**WHITEMARSH TOWNSHIP
PLANNING COMMISSION MEETING (IN-PERSON)
AMENDED AGENDA
JANUARY 13, 2026
6:30 PM**

- SLD #08-25 608 Germantown Pike Associates LLC; Sketch Plan for 22 Dwelling Units; 604-608 Germantown Pike

CONCEPT LAYOUT 'B1'
 DEVELOPMENT STUDY EXHIBIT
 604-608 GERMANTOWN PIKE
 WHITE MARSH TOWNSHIP - MONTGOMERY COUNTY - PENNSYLVANIA
 Layer List:
 Job No: Exh_CPT-B1
 Plan Date: 25-0401 D
 Sheet No: JULY 29, 2025
 1 of 1

PENNDOT HIGHWAY OCCUPANCY PERMIT REQUIRED

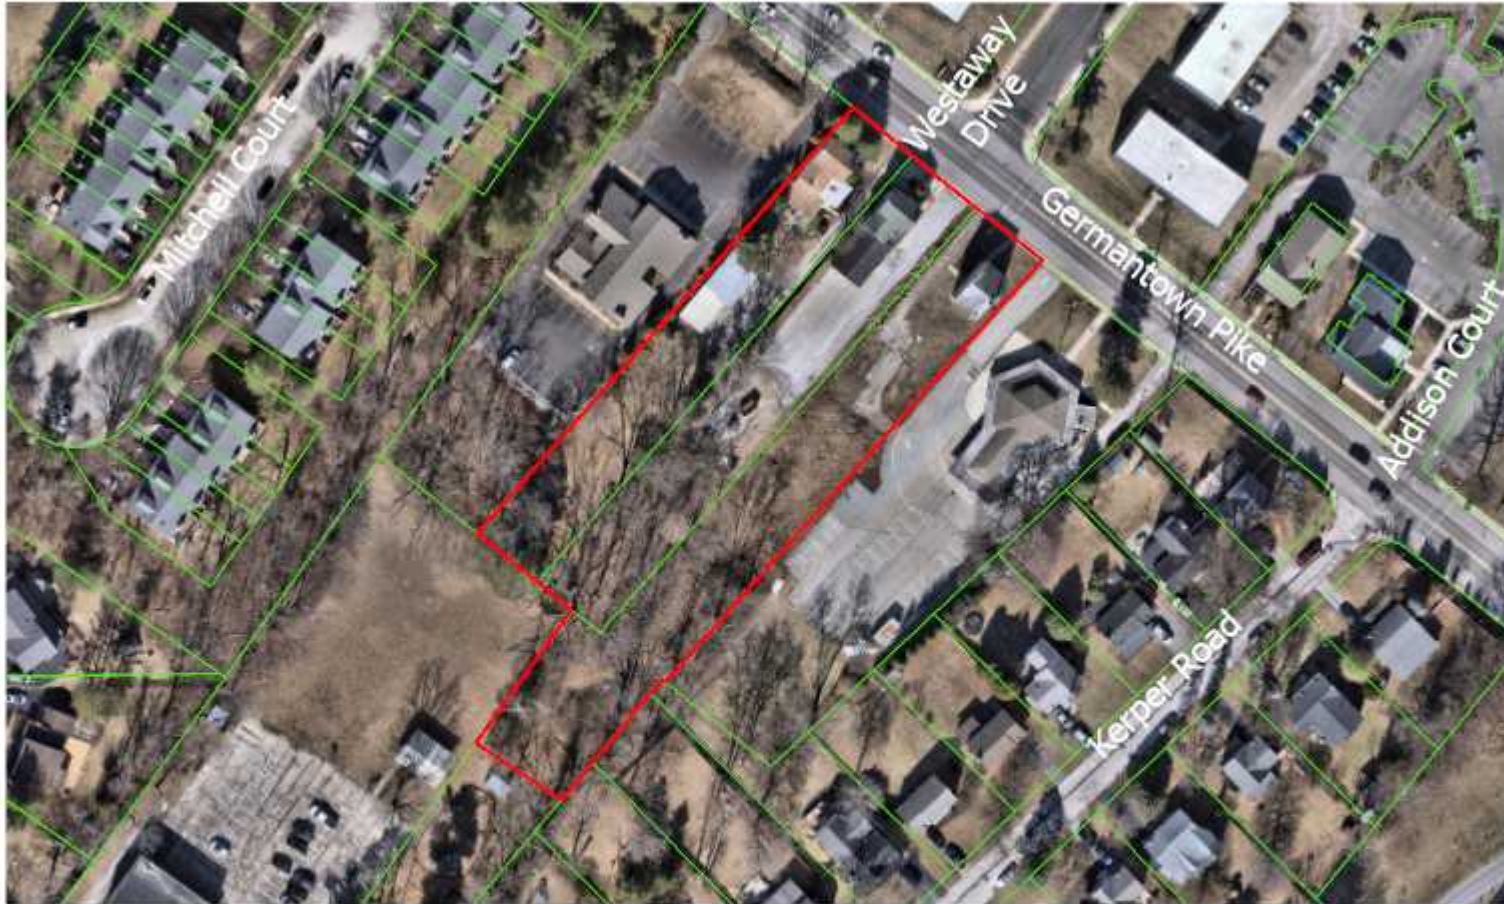
The development site is located on Germantown Pike, which is identified in *Bike Montco : The Bicycle Plan for Montgomery County* as a 'Principal Arterial' route connecting Butler Pike, the City of Philadelphia, and the nearby Wissahickon Valley Park (pg. 71). The plan, adopted by the Montgomery County Board of Commissioners in June 2018, seeks to improve bicycle mobility, connectivity, and safety throughout the county. The township and applicant are encouraged to discuss if bicycle infrastructure can be accommodated as part of this proposal, whether that be through on-site infrastructure (i.e., bicycle storage and/or maintenance facilities) or through on-street signage or pavement markings (e.g., sharrows, "share the road" signage, etc.).

Germantown Pike is a PennDOT roadway and, as such, a PennDOT highway occupancy permit will be required for any work within the right-of-way. The township and applicant are encouraged to begin coordination with PennDOT early on in the process to ensure that ingress/egress points are properly planned for and to avoid future revisions. We have copied PennDOT staff on this letter.
